B 3.3 INSTRUMENTATION

B 3.3.1 Reactor Protection System (RPS) Instrumentation

- A1 The designated change represents a non-technical, non-intent change to the Arkansas Nuclear One, Unit 1 Current Technical Specifications (CTS) made to make the ANO-1 Improved Technical Specifications (ITS) consistent with the B&W Standard Technical Specification (RSTS), NUREG-1430, Revision 1. This change does not alter the requirements of the CTS or NUREG. Examples of this type of change include: wording preference; convention adoption; editorial, numbering and formatting changes; and hierarchy structure.

SR 3.3.1.3

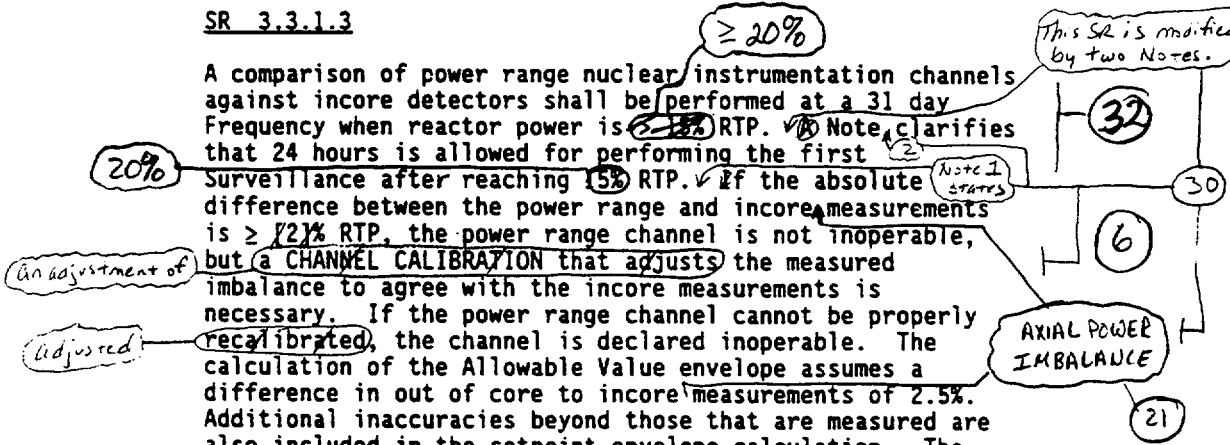
A comparison of power range nuclear instrumentation channels against incore detectors shall be performed at a 31 day Frequency when reactor power is ~~20%~~ ^{≥ 20%} RTP. ~~Note~~ ^{Note 1} clarifies that 24 hours is allowed for performing the first ² surveillance after reaching ~~5%~~ ^{5%} RTP. ^{Note 1 states} If the absolute difference between the power range and incore measurements is ~~≥ 12%~~ ^{≥ 20%} RTP, the power range channel is not inoperable, but a CHANNEL CALIBRATION that ~~adjusts~~ ^{adjusts} the measured imbalance to agree with the incore measurements is necessary. If the power range channel cannot be properly ~~recalibrated~~ ^{recalibrated}, the channel is declared inoperable. The calculation of the Allowable Value envelope assumes a difference in out of core to incore measurements of 2.5%. Additional inaccuracies beyond those that are measured are also included in the setpoint envelope calculation. The 31 day Frequency is adequate, considering that long term drift of the excore linear amplifiers is small and burnup of the detectors is slow. Also, the excore readings are a strong function of the power produced in the peripheral fuel bundles, and do not represent an integrated reading across the core. The slow changes in neutron flux during the fuel cycle can also be detected at this interval.

RMI 3.3.1-06

<Add 3.3.5 Appl. & Table 3.3.5-1 Applicable MODES or Other Specified Condition>

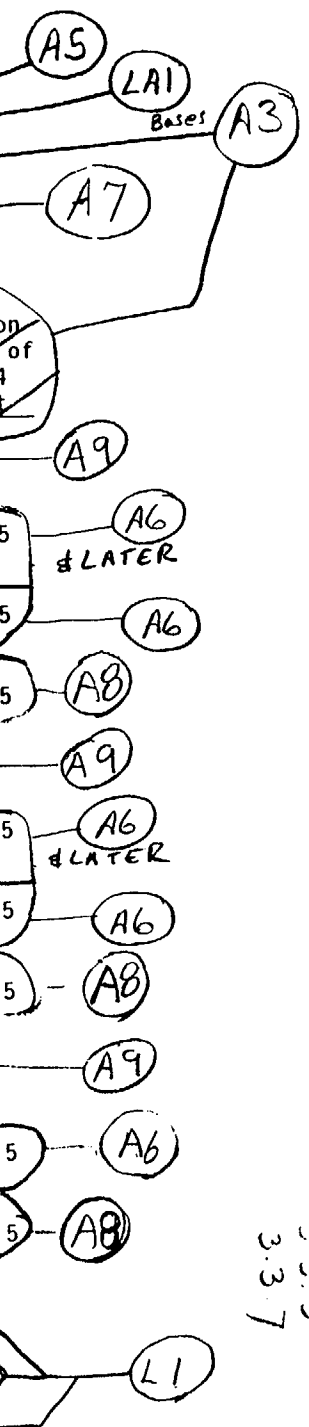
<Add 3.3.5 RA B.2.2 Note>

<Add 3.3.5 RA B.2.1 with NOTE>

< Add 3.3.6 RA A.1 >
 < Add 3.3.7 RA A.1 >
